**A38 Derby Junctions**

**Appendix 3.3: Options Assessment –  
Little Eaton – Options 2A, 2B, X and X1**

## **Options Assessment: Little Eaton Options 2A, 2B, X and X1**

**Report No: 47071319-URS-06-RP-RDN-024  
July 2016**

Drawing Title  
**LITTLE EATON  
OPTION 2A  
GENERAL LAYOUT  
PLAN**

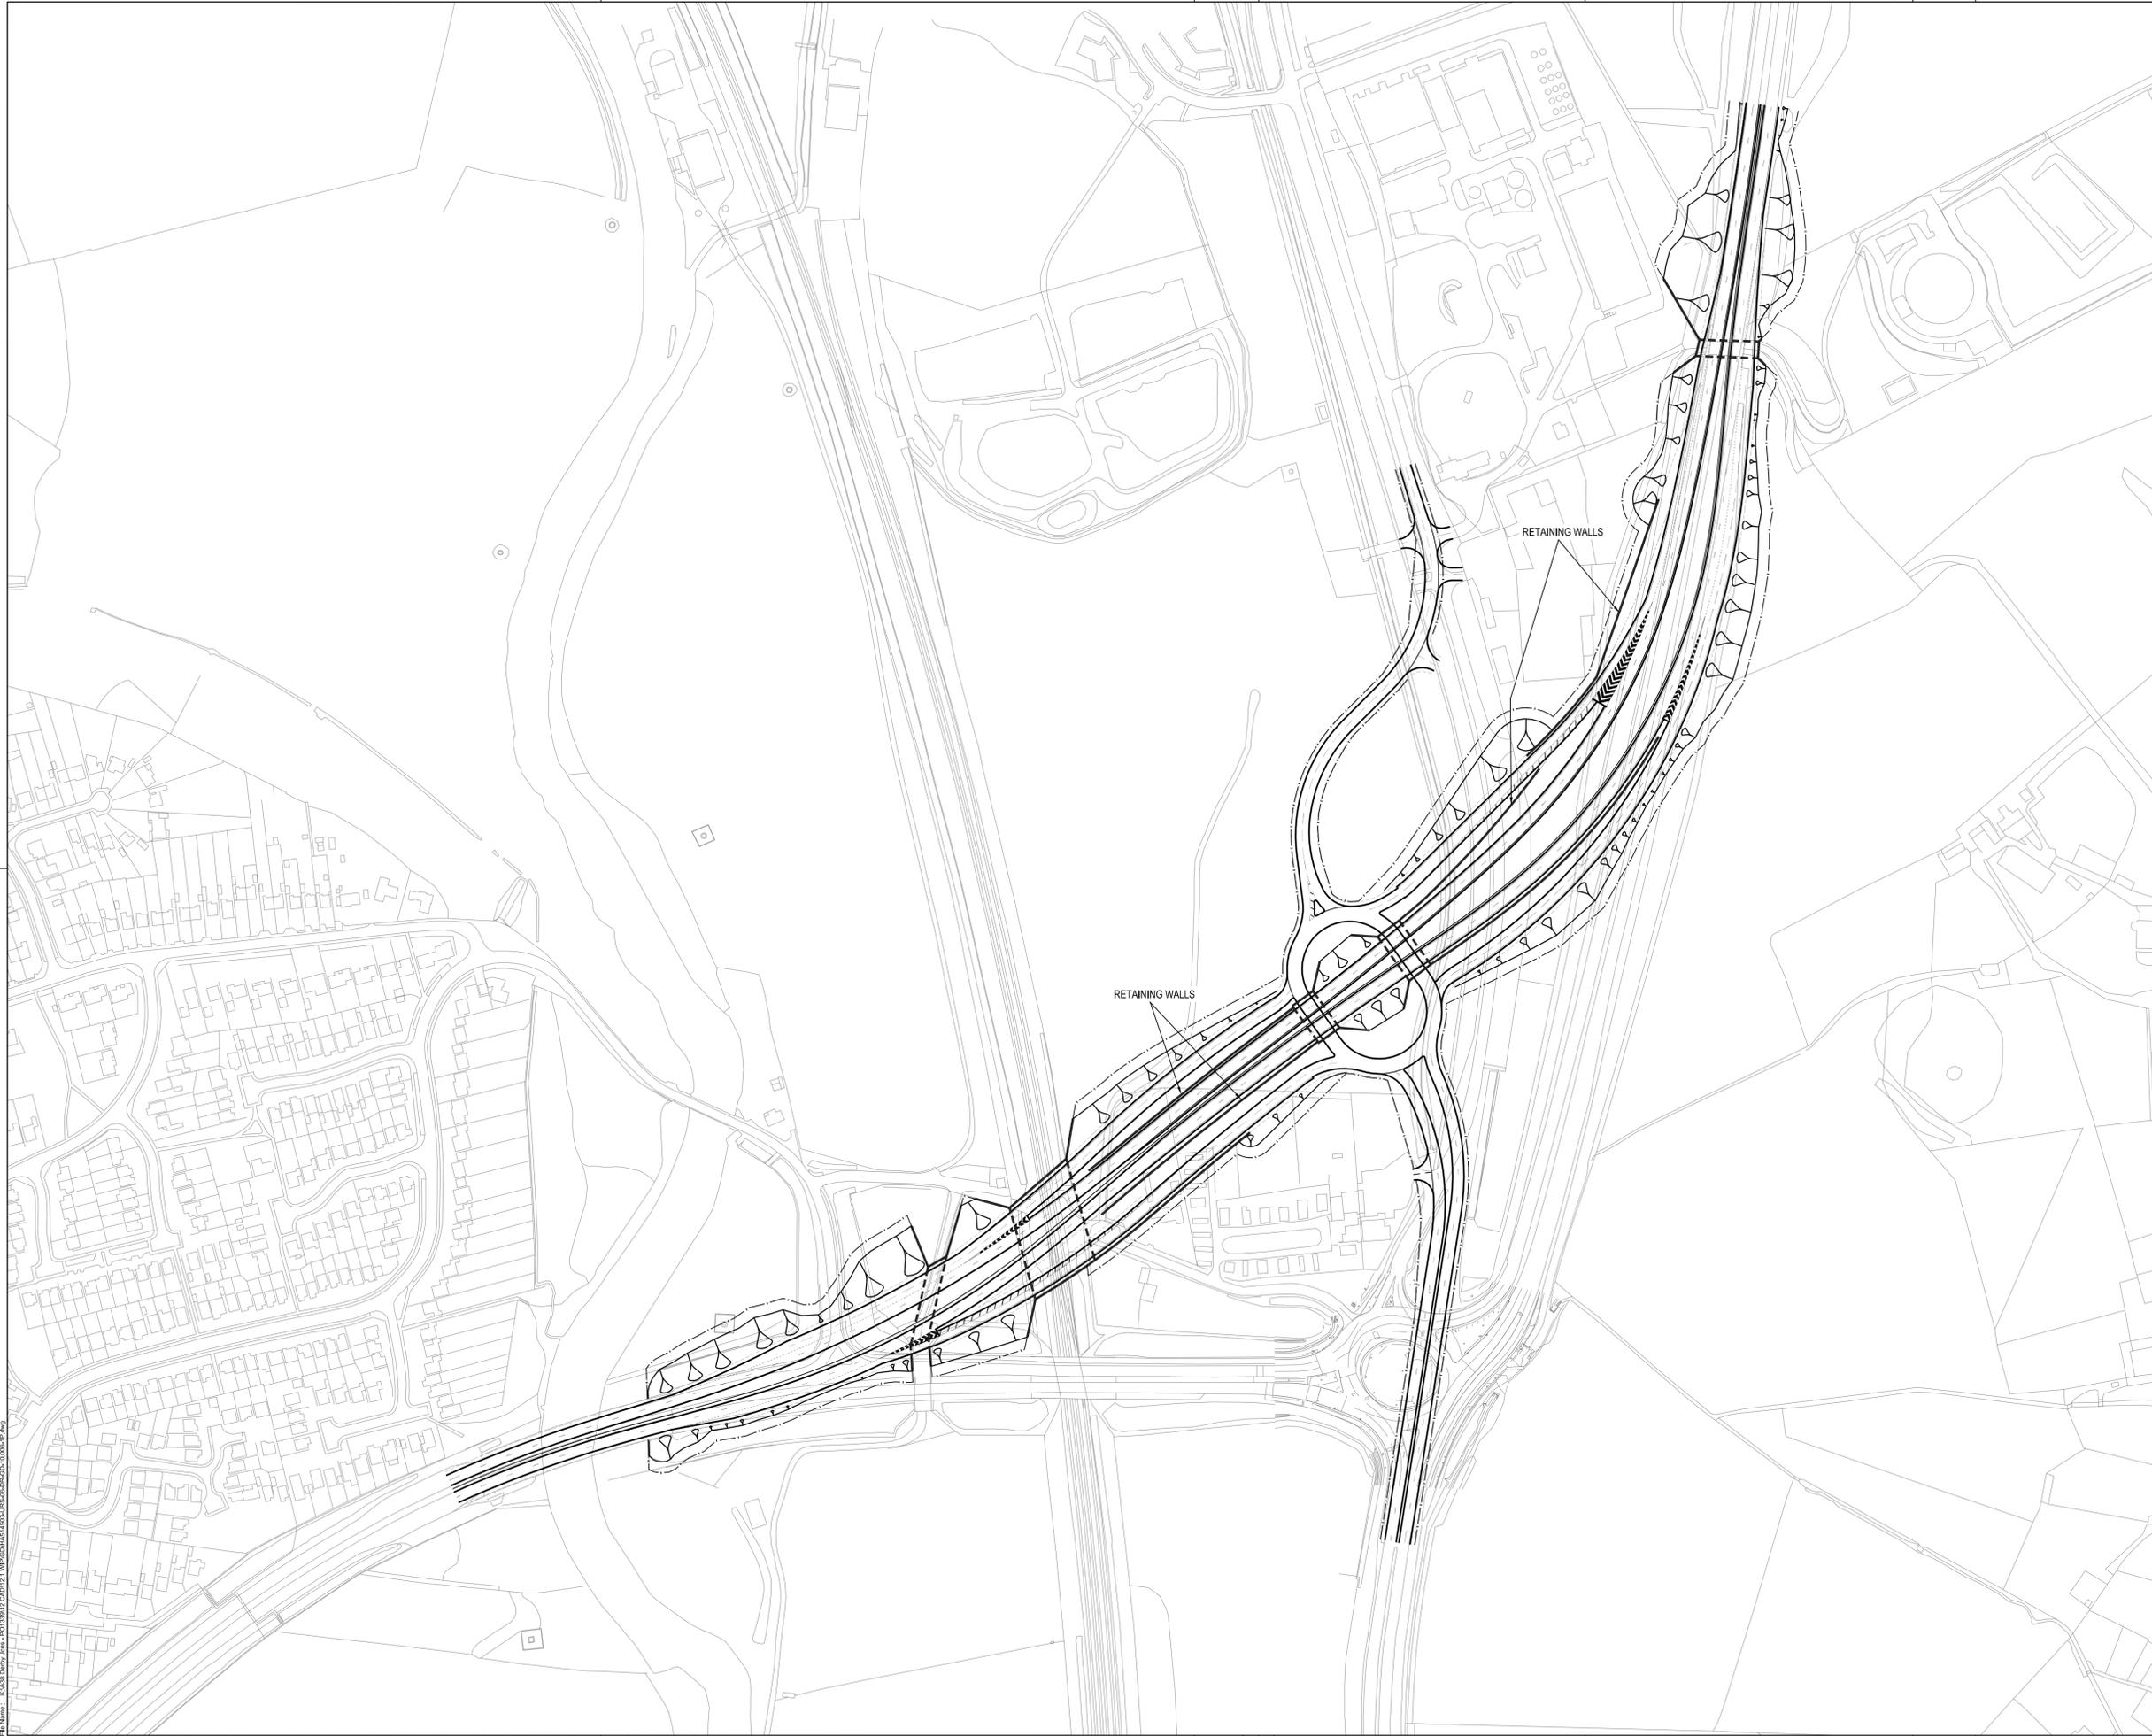
Reference		Description of the Alternative Option
Option 2A		This option is a development of Option 2 whereby the northbound slip roads are re-configured and the southbound slip roads reuse the existing A38 carriageway. See drawing no. HA514503-URS-06-DR-GD-10.007.
Submitted by:		
Breadsall A38 Action Group		
Alternative option for Little Eaton Junction		
Objectives Categorisation		
Objective Description	Score	Comments
<b>Objective 1</b> 'To reduce congestion and increase reliability of journey times on the strategic corridor'	4	Overall, the junction will improve journey times compared to the existing arrangement by removing the need for all A38 through traffic to negotiate the roundabout. The proposed A38 alignment would enable the junction to operate at 70mph design speed, slightly improving journey times compared to the Presented Option. In this regard it is comparable to Option 2. However, as a result of the double roundabout junction, non-through traffic will be delayed compared to a single roundabout solution. The slip road layouts are simpler and shorter than those required for Option 2 but the roundabouts will need careful design to ensure potential congestion is minimised for traffic moving between the A38 and A61. Note: The link between roundabouts may need to be multiple lanes to accommodate the design year flows. On balance the score is similar to the Presented Option.

<b>Objective 2</b> 'To minimise traffic disruption due to construction works and incidents'	4	The option is comparable to Option 2. Compared to the Presented Option, Option 2A is constructed more offline. Consequently, a reduced amount of works on the existing A38 is required. This will provide extra flexibility in traffic management and less disruption to road users during construction.
<b>Objective 3</b> 'To achieve optimum whole life costs taking into account future maintenance and operation, and disruption to users'	3	Compared to Option 2, the cost of Option 2A will be slightly reduced due to the re-use of the existing slip roads and the retention of the garden centre reducing land costs. However, these are unlikely to offer a significant enough saving to address the overall cost increase compared to the Presented Option. As such, the cost differences are likely to remain in excess of 10% and the score is comparable to Option 2. There are no features which would significantly affect maintenance costs compared to other options.

<b>Objective 4</b> 'To minimise impacts on both the natural and built environment, including designated landscape/biodiversity features'	2	This layout is comparable to Option 2 in that (i) there will be a reduced visual impact for residents in Breadsall compared to the Presented Option; (ii) there will be a large impact to the mobile homes park and adjacent property "Fourways" due to the proximity of the route and land take; (iii) new bridge over the railway would have adverse effect on World Heritage Site and cause additional landscape effects; (iv) potential additional ecological and flood risk impacts comparable to the Presented Option. Note: Without the proposed amendments to the garden centre car park, the land take would result in its potential closure. Scoring is based upon the garden remaining open at this stage.
<b>Objective 5</b> 'To seek to mitigate impacts on air quality and noise'	3	The score is comparable to Option 2. Option 2A would reduce air quality effects in some locations and increase them elsewhere as compared to the Presented Option, whilst the overall noise effects of Option 2A are likely to be neutral as compared to the Presented Option (although slip road could result in additional noise impacts upon mobile home park).

<b>Objective 6</b> 'To improve the safety for all road users'	3	The slip road layout has been simplified thereby improving safety for road users. The design retains the double-roundabout arrangement which maintains the likelihood of vehicle incidents as the Option 2. Additionally, in order to keep the southbound merge slip road within the footprint of the existing A38, it would be necessary to remove the auxiliary lane from Option 2 and provide a merge nose with a more severe approach angle. While it is expected that a Departure for this would be granted, it would impact safety and capacity to a small degree. Overall, the differences are not sufficient to affect the scoring and the option is considered to be comparable to Option 2 in terms of roads user safety. NOTE: A variant has been developed with a compliant slip road layout (see <i>Option 2A variant</i> ).
<b>Objective 7</b> 'To seek to reduce severance by maintaining or providing appropriate facilities for crossing, and travelling along the route for non-motorised users'	3	The score is comparable to Option 2 as there are no significant changes planned which would affect NMUs. No NMU routes will be permanently severed.

<b>Objective 8</b> 'To be affordable and represent High Value for Money according to DfT's appraisal criteria'	3	Scheme is expected to represent good value for money in terms of BCR. Compared to the Presented Option, benefits are expected to be similar (see objective 1) but costs are expected to be higher (see objective 3). In addition, there will be additional costs associated with purchasing the mobile homes. Overall, this results in a lower score compared to the Presented Option.
<b>Average Score</b>	3.125

Reference		Description of the Alternative Option
Option 2A		This option is a development of Option 2 whereby the northbound slip roads are re-configured and the southbound slip roads reuse the existing A38 carriageway. See drawing no. HA514503-URS-06-DR-GD-10.007.
Submitted by:		
Breadsall A38 Action Group		
Alternative option for Little Eaton Junction		
Deliverability Categorisation		
Factors considered	Score	Comments
<p>Is there a risk that will prevent us from progressing this option?</p> <p>What level of stakeholder/public support/challenge is expected for this option?</p> <p>Are there any significant third party issue associated with the option?</p> <p>Are there any political issues associated with this option?</p> <p>Are there any planning/legal issues associated with this option?</p> <p>Does the option impact the overall project deliverability?</p>	2	<p>The option requires the CPO of land currently occupied by the car park to the Derby Garden Centre. The area of land is sufficiently large to make the garden unviable as an ongoing business. The option proposes purchasing land from the existing landfill site to replace the lost car park area. Examination of the CPO powers, governed under the Planning Act 2008 for Development Consent Order (DCO) applications, has shown that this is not possible under legislation. The powers only relate to purchasing land that is an integral part of the principle proposed development or defined as associated development. The Department for Communities and Local Government guidance on associated development lays out the type of land that can be included. The proposed arrangement is not listed within the guidance and hence, is not covered by the legislation. Pursuing such an arrangement would therefore be beyond the legal powers.</p> <p>As a consequence, the only way this land could be obtained for the purpose of a replacement car park would be by negotiation. As the scheme could not proceed without the land, the landowner could effectively control the price of the land or may not wish to sell the land at all. This is expected to be costly and difficult to secure until later stages in the project when funding is available. This puts the Option at risk and presented a major deliverability challenge.</p> <p>As such, the only remaining option would be to purchase the Derby Garden Centre. This is estimated at £2m and contributes to the higher project cost (see objective 3). Consequently, this presents a major deliverability challenge. In the event that the amended car park could not be provided, the only alternative would be for the car park to be extended south, into the land owned by garden centre, with foot access provided around the junction from the car park to garden centre (approx. 300m walking distance). However, this is unlikely to be either safe or practicable and would be likely to lead to the business becoming unviable.</p>

Feasibility Categorisation		
Factors considered	Score	Comments
<p>Is the option technically sound?</p> <p>Is the option financially affordable?</p> <p>Is the option buildable?</p> <p>Is the option likely to be practical and effective?</p> <p>Does the option impact the overall project feasibility</p>	3	No additional benefits or drawbacks when compared with Presented Option.

# OPTION 'X1'

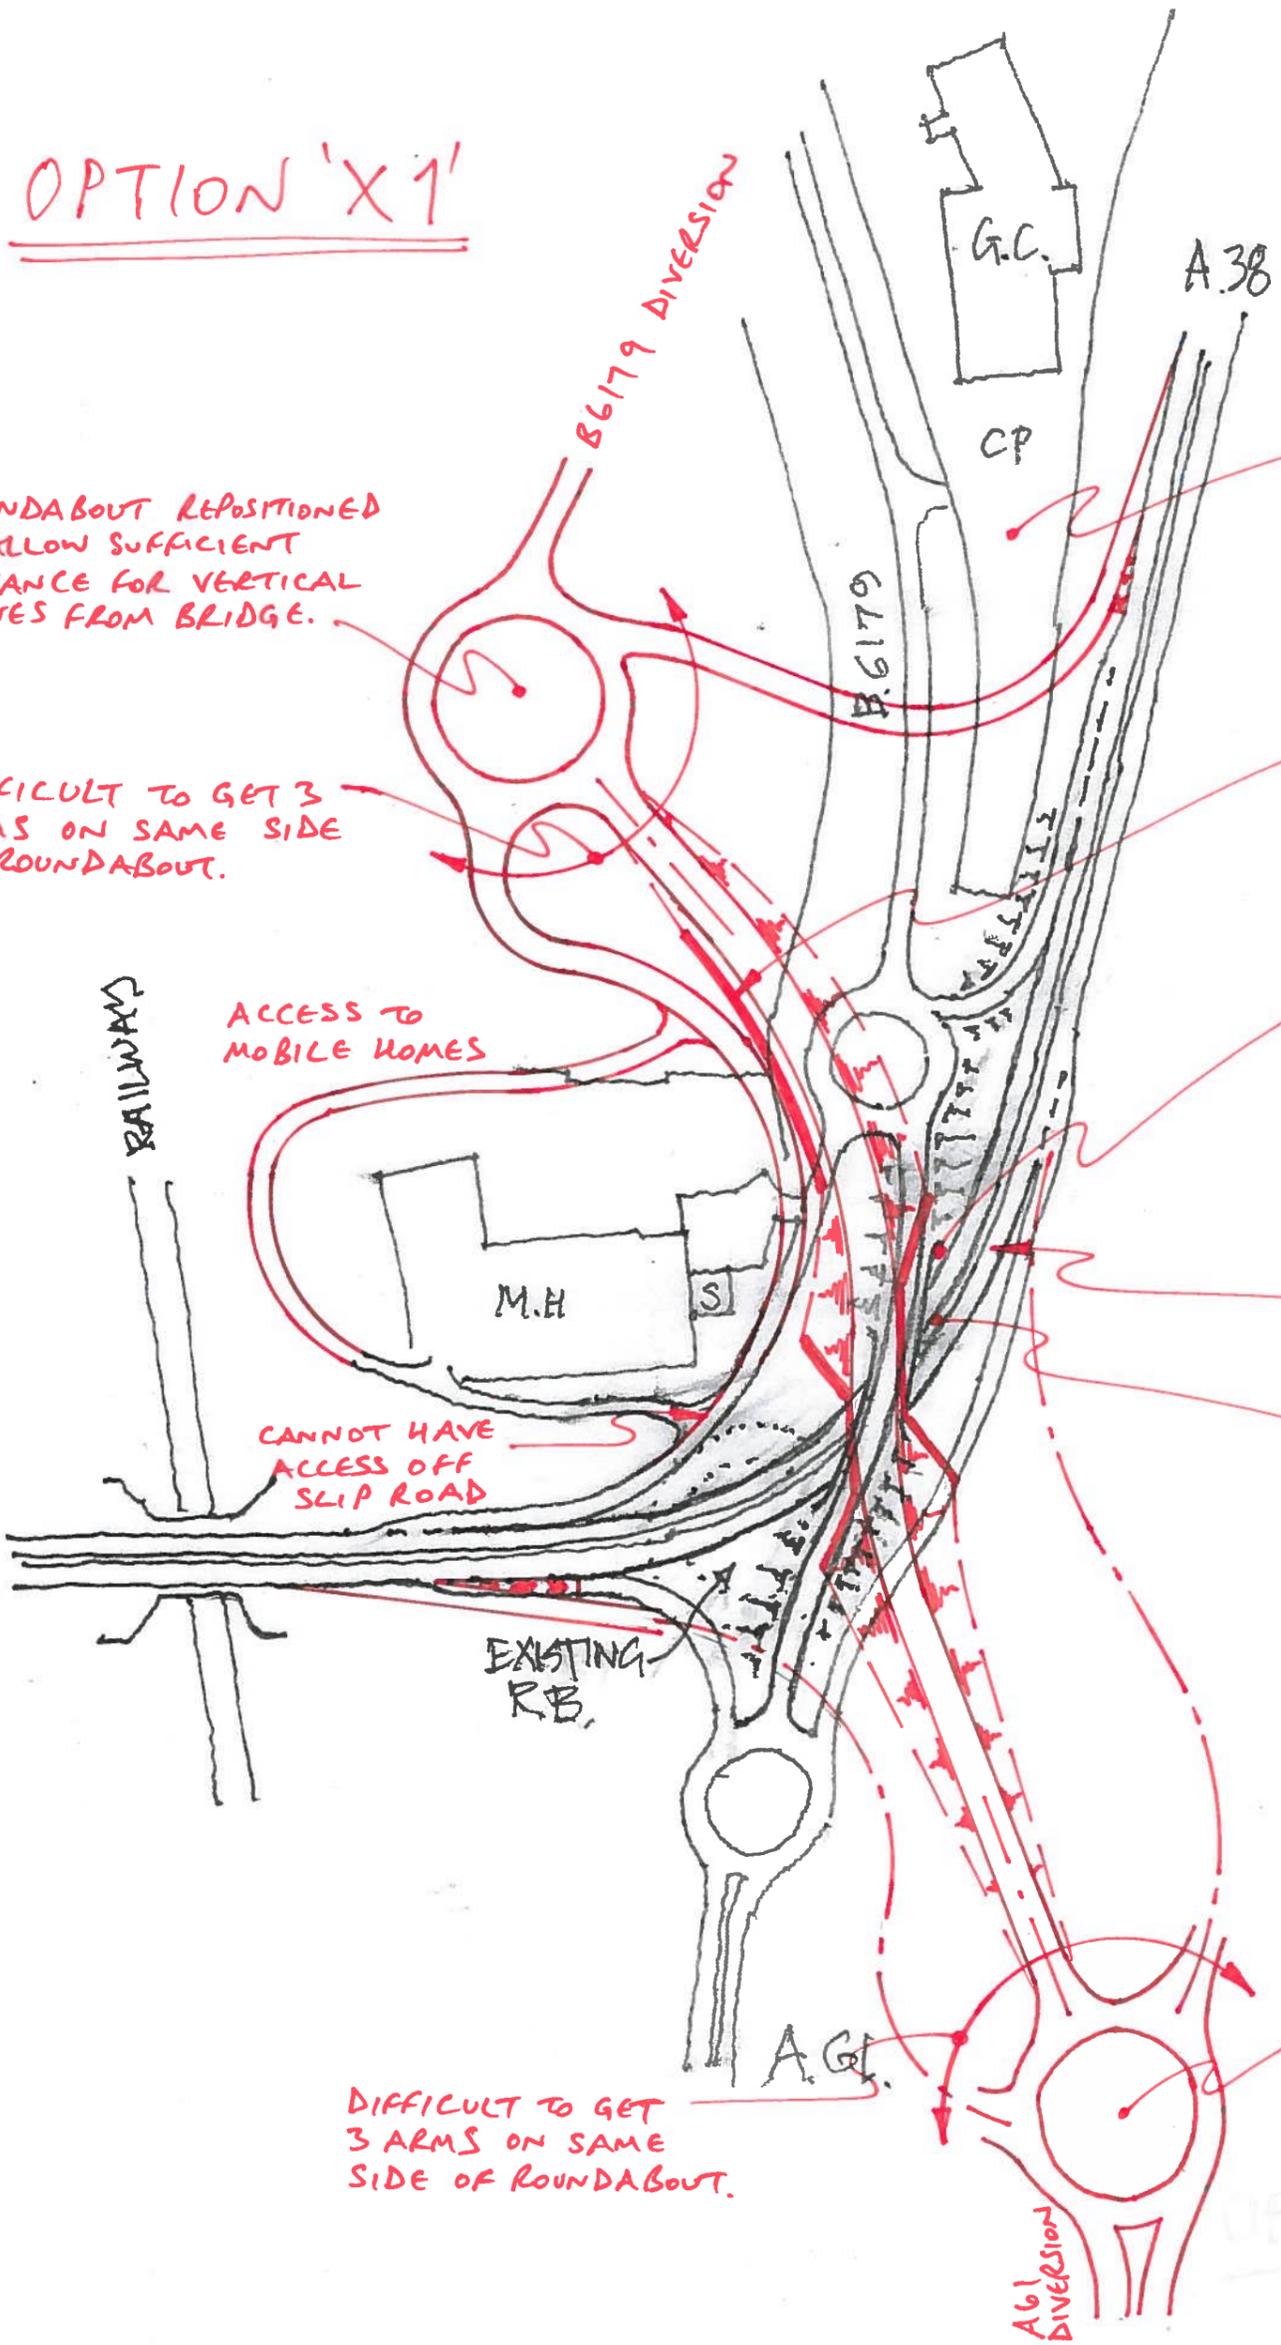
ROUNDAABOUT REPOSITIONED TO ALLOW SUFFICIENT DISTANCE FOR VERTICAL CURVES FROM BRIDGE.

DIFFICULT TO GET 3 ARMS ON SAME SIDE OF ROUNDAABOUT.

CANNOT HAVE ACCESS OFF SLIP ROAD

DIFFICULT TO GET 3 ARMS ON SAME SIDE OF ROUNDAABOUT.

CAR PARK AFFECTED.

VERGE WIDTH NEEDS TO BE 7m WIDE THROUGH BRIDGE.

~ 150m RADIUS PROBABLY NEEDS 40MPH MANDATORY SPEED LIMIT (70AKPH DESIGN SPEED).

CENTRAL RESERVE WIDTH NEEDS TO BE ~ 8m WIDE FOR VISIBILITY.

ROUNDAABOUT REPOSITIONED TO ALLOW SUFFICIENT LENGTH TO GET UP TO BRIDGE, AND PROVIDE SPACE TO PERMIT AN APPROPRIATE ALIGNMENT FOR THE SOUTHBOUND MERGE SLIP ROAD.
